ASSESSMENT REPORT

PROJECT:	2 Fishburn Crescent Castle Hill NSW 2154
STAGE:	Development Application Phase
REFERENCE:	24010.4-BCA
DATE:	15 September 2025
CLIENT:	ARADA Development Management Pty Ltd

Figure 5.2 – General bin holding area and associated airlock on ground level

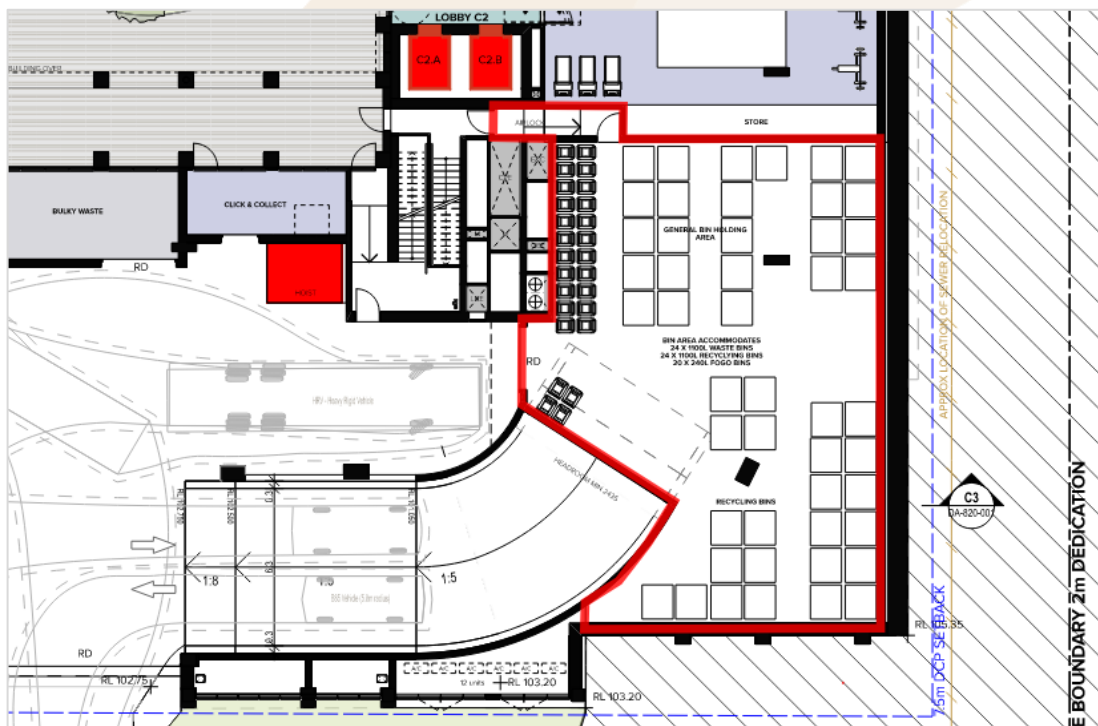
BCA Clause	Comment/s	Status
D2D3	<p>Number of exits</p> <p>The provision of a single exit in lieu of two is identified at the following locations –</p> <ul style="list-style-type: none"> (a) General bin holding area and associated airlock on ground floor level; (b) Plant rooms and associated airlock on the upper ground level. <p>Notwithstanding the above, the following egress provisions are identified as being provided -</p> <ul style="list-style-type: none"> (a) in addition to any horizontal exit, not less than 2 exits must be provided from each storey; (b) access to at least 1 exit, where a part of a storey is provided with direct egress to a road or open space; and satisfies the exit travel distance requirements of D2D5 of the BCA by the provision of 1 exit; and (c) without passing through another sole-occupancy unit every occupant of a storey or part of a storey must have access to— <ul style="list-style-type: none"> (i) an exit; or (ii) at least 2 exits if 2 or more exits are required. <p><i>NOTE – the roof level serving the plant spaces has been assessed as <u>not</u> being covered by roof and accessed only for maintenance and hence not assessed as an occupiable outdoor area.</i></p>	DNC / PPS

Figure 5.5 – Basement 01 exit travel distances

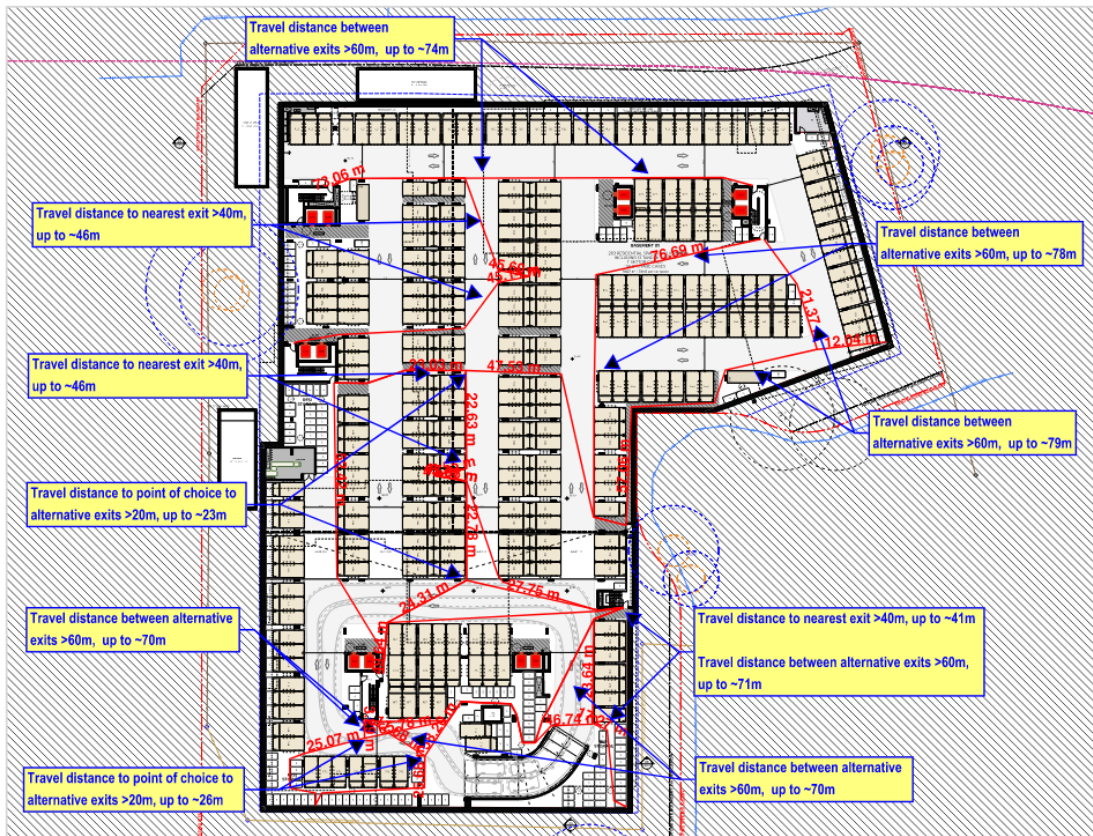
BCA Clause		Comment/s	Status
D2D5	Exit distances travel	<p>Extended exit travel distances are identified as occurring throughout the building, as follows –</p> <p>(a) <i>Basement 02</i> -</p> <p>(i) The travel distance to a point of choice to alternative exits exceeds 20m, being up to ~25m;</p> <p>(ii) The travel distance to the nearest exit exceeds 40m, being up to ~46m.</p> <p>(b) <i>Basement 01</i> -</p> <p>(i) The travel distance to a point of choice to alternative exits exceeds 20m, being up to ~26m;</p> <p>(ii) The travel distance to the nearest exit exceeds 40m, being up to ~46m.</p> <p>(c) <i>Lower Ground</i> -</p> <p>(i) The travel distance to a point of choice to alternative exits exceeds 20m, being up to ~24m;</p> <p>(ii) The travel distance to the nearest exit exceeds 40m, being up to ~44m;</p> <p>(iii) The travel distance to an exit from the discharge of the horizontal exit serving the carpark part exceeds 20m, being up to ~38m;</p> <p>(iv) The travel distance from the unit entry door to the exit at the level of egress to open space exceeds 20m, being up to ~21m.</p> <p>(d) <i>Ground Level</i> -</p> <p>(i) The travel distance from the maintenance workshop to a point of choice to alternative exits exceeds 20m, being up to ~27m;</p> <p>(ii) The travel distance to the single exit from the general bin holding area exceeds 20m, being up to ~27m;</p> <p>(iii) The travel distance from a unit entry to a point of choice to alternative exits exceeds 6m, being up to ~16m.</p> <p>(e) <i>Upper Ground</i> -</p> <p>(i) The travel distance from a unit entry door to a point of choice to alternative exits exceeds 6m, being up to ~12m;</p> <p>(ii) The travel distance to the single exit from the plant room exceeds 20m, being up to ~21m.</p> <p>(f) <i>Level 1 – Level 10</i> –</p> <p>(i) The travel distance from a unit entry door to a point of choice to alternative exits exceeds 6m, being up to ~12m.</p> <p>(g) <i>Level 11 – Level 13</i> -</p> <p>(i) The travel distance from a unit entry door to a point of choice to alternative exits exceeds 6m, being up to ~9m.</p> <p>(h) <i>Level 18</i> –</p> <p>(i) The travel distance from the communal terrace area to a point of choice to alternative exits exceeds 20m, being up to ~28m.</p>	DNC / PPS

Figure 5.25 – Area below driveway ramp on Basement 02

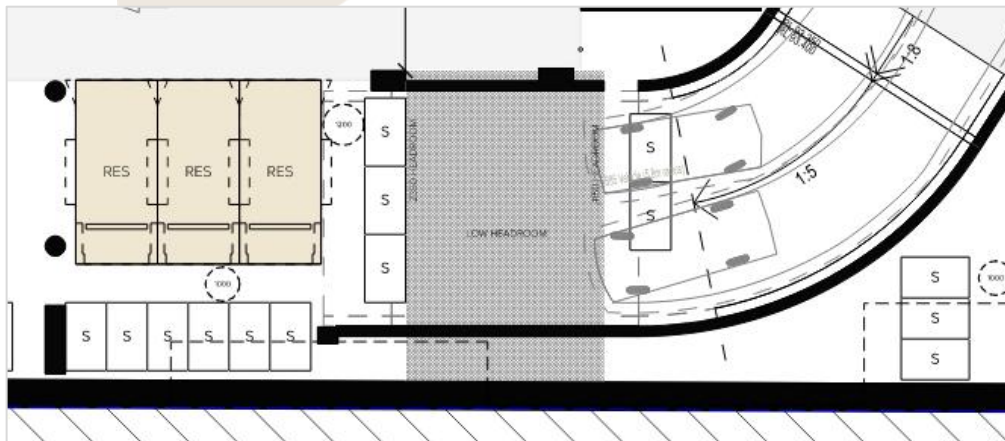
D2D7	<p>Heights of exits, paths of travel to exits and doorways</p>	<p>The height clearance below the driveway ramp at Basement 02 is identified as being less than 2m, being not less than 1.15m.</p> <p>Notwithstanding the above, in a required exit or path of travel to an exit the unobstructed height throughout must be not less than 2 m, except the unobstructed height of any doorway may be reduced to not less than 1980 mm.</p>	DNC / PPS

Figure 5.28 – Discharge from fire isolated exits FS.A1

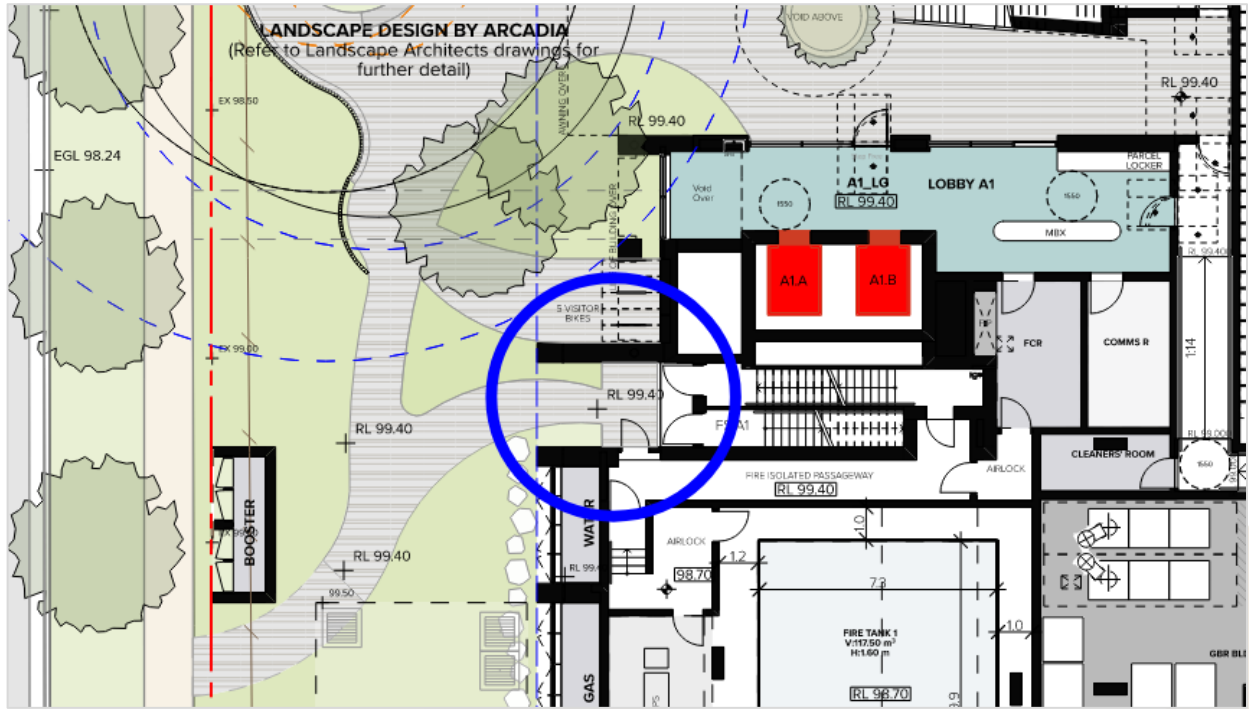
D2D15	Discharge from exits	<p>The following fire isolated stairways serving as alternative exits from the corresponding residential parts are identified as discharging at a point that is not located as far apart as practical –</p> <p>(a) FS.A1 fire isolated stairways serving A1 residential parts;</p> <p>(b) FS.B2 fire isolated stairways serving B2 residential parts;</p> <p>(c) FS.C2 fire isolated stairways serving C2 residential parts.</p> <p>Notwithstanding the above, the following must be complied with -</p> <p>(1) An exit must not be blocked at the point of discharge and where necessary, suitable barriers must be provided to prevent vehicles from blocking the exit, or access to it.</p> <p>(2) If a required exit leads to an open space, the path of travel to the road must have an unobstructed width throughout of not less than—</p> <p>(a) the minimum width of the required exit; or</p> <p>(b) 1 m,</p> <p>whichever is the greater.</p>	DNC / PPS
